Proposed Amendment to the Approved Kwu Tung South Outline Zoning Plan No. S/NE-KTS/22 From “Agriculture” Zone and “Green Belt” Zone to “Government, Institution or Community” Zone at Various Lots in D.D.94, 98 & 100 and Adjoining Government Land, Kwu Tung South, New Territories (TPB Ref. Y/NE-KTS/18)
Responses to Comments Table

Comments/ Suggestions	Applicant/ Consultant’s Responses
<p>A. Comments from Urban Design Unit, Urban Design & Landscape Section of Planning Department received from Planning Department on 22.12.2025: (Contact person: Ms. LEE Wing Ki, Nicole, Tel no.: 3565 3945)</p>	
<p><u>VIA</u> Please explore the following VPs: <u>Short ranged VP</u></p> <p>1. Sheung Shui Hang Tau Village Sitting-out Area No. 2,</p> <p><u>Medium to long ranged VPs</u></p> <p>2. Ngau Tam Shan, and</p> <p>3. Lam Tsuen Country Park/ Kai Kung Leng.</p> <p><u>AVA</u></p> <p>(a) The following points are unclear in the Air Ventilation Review:</p> <p>i. ‘400m track with ball courts’ is adopted in the Air Ventilation Review, but this facility is not mentioned in planning statement nor architectural drawings.</p> <p>ii. S Wind (Figure 4b) – the breezeway on the right of the figure appeared to be enc

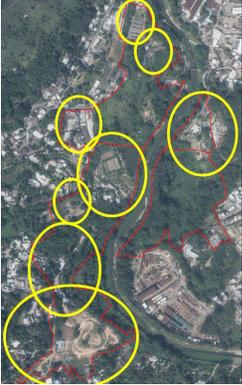
Comments/ Suggestions	Applicant/ Consultant’s Responses
<ul style="list-style-type: none"> - Please also include the measures for the mitigating the gaseous emissions from the NRMM and PMEs during construction phase. <p>7. Section 3.6:</p> <ul style="list-style-type: none"> - Please confirm whether the tunnel portal and/or ventilation building of the Northern Metropolis Highway lies within the assessment area. If so, include them in the assessment. - Please check whether the latest alignment of the San Tin Technopole Interchange is available, as a large portion of the proposed development falls within its indicative location. An additional buffer may be required. - Please check whether the proposed public road is collocated with ASR A13. - Please include the assessment for the new public road and the widening of the existing public road if these works are part of the project. If they are not, state this clearly. - Please discuss if there are chimneys or other polluting uses within the proposed development. - Please identify if there are any planned chimneys within the assessment area. 	<p>projects with a site area of approx. 12 ha and depth of filling, the number of on-site diesel/petroleum fuelled machinery (10-15 machineries) to be used for construction works (i.e. site clearance, formation and excavation), subject to detailed design. Please refer to updated Sections 3.5.1 and 3.5.2 of the revised EA for details (Attachment 6 refers).</p> <p>Please refers to the response in the Column above in response to Comment B6 bullet point 1.</p> <p>According to the available information from Highways Department, there is no detailed design / relevant information regarding the tunnel portal / ventilation building of the Northern Metropolis Highway provided tentatively. Relevant assessment will be conducted in detailed design stage upon obtaining relevant information.</p> <p>According to the available information from Highways Department, the latest alignment of the San Tin Technopole Interchange is not available tentatively. Relevant assessment will be conducted in detailed design stage upon obtaining relevant information.</p> <p>Location of A13 has been revised in Figure 3.1 of the revised EA (Attachment 6 refers).</p> <p>The new public road is a part of the project, and the corresponding assessment has been updated in Section 3.6 and Figure 3.3 of the revised EA, which indicates the 5m buffer distance requirement is met for existing air sensitive uses / air sensitive receiver (Attachment 6 refers).</p> <p>In addition, according to the latest design and available information, no chimney or other polluting uses within the Indicative Development Scheme and 200m assessment area is proposed. As such, it is anticipated that the Indicative Development Scheme and existing air sensitive receivers would not be subject to adverse industrial emission impact. Please refer to Section 3.6.1 of the revised EA (Attachment 6 refers).</p> <p>In addition, according to the latest design and available information, there are no planned chimney or other polluting uses within Indicative Development Scheme or located within the 200m assessment area. As such, it is anticipated that the Indicative Development Scheme and existing air sensitive receivers would not be</p>

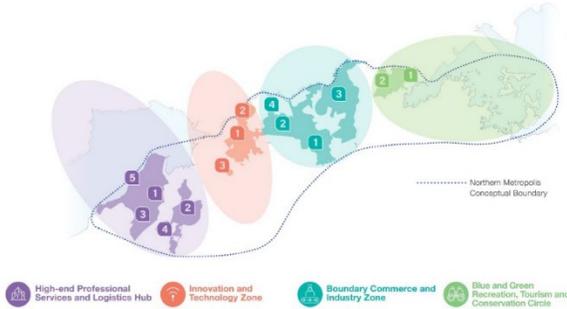
Comments/ Suggestions	Applicant/ Consultant’s Responses
	<ul style="list-style-type: none"> The Agri-Park Phase 1, jointly developed by the AFCD and CEDD, located at 1km to the south of the proposed G/IC Zone, has commenced operation progressively since late 2022 (LC Paper No. CB(2)76/2025(01)). It aims to nurture agro-technology and knowledge on modern farm management, so as to enhance productivity and promote the modernization and sustainable development of local agricultural industry. According to Consultation Document for New Agricultural Policy: Sustainable Agricultural Development in Hong Kong (FHB and AFCD, 2014), the Agri-Park is intended to be a hub for commercial farming and advanced agricultural technology in Hong Kong. <p>These above-mentioned major on-going and planned developments, in the broader context of the Northern Metropolis and closer integration with the Guangdong–Hong Kong–Macao Greater Bay Area (GBA), have already begun to transform the area from a predominantly rural setting into a highly impacted area and infrastructure-led landscape.</p> <p>No ecological sensitive receivers identified</p> <p>In various studies on ecological feasibility/capacity of the above-mentioned developments, no significant ecological sensitive receivers have been identified within the proposed G/IC Zone and its immediate vicinity. No existing ecoretries have been reported within/around the Application Site. No nearby streams have been included among the 33 Ecologically Important Streams (EIS) identified by AFCD.</p> <p>The nearest major designated/recognised conservation areas, from the proposed G/IC Zone, are Lam Tsuen Country Park (approximately 1.9 km to the south) and Long Valley Nature Park (approximately 1.8 km to the northeast). Overall, the available information indicates that the Application Site and its close surroundings are of relatively low ecological value and ecological sensitivity in the local and territorial context.</p> <p>Wildlife species are largely common elsewhere in Hong Kong</p> <p>According to the approved EIAs for nearby strategic and/or major infrastructure development projects, including North East New Territories New Development Areas (AEIAR-175/2013), San Tin/ Lok Ma Chau Development Node (AEIAR-302/2032), Northern Link (AEIAR-259/2024) and Development at Ngau Tam Mei Area (AEIAR-271/2025), most wildlife species recorded in the wider area mainly comprise species that are common and typical of disturbed, lowland habitats in Hong Kong.</p> <p>The applicant has acquired ecological knowledge of the site through desk-based study, project-specific site visits and on-ground observations, review of previous</p>
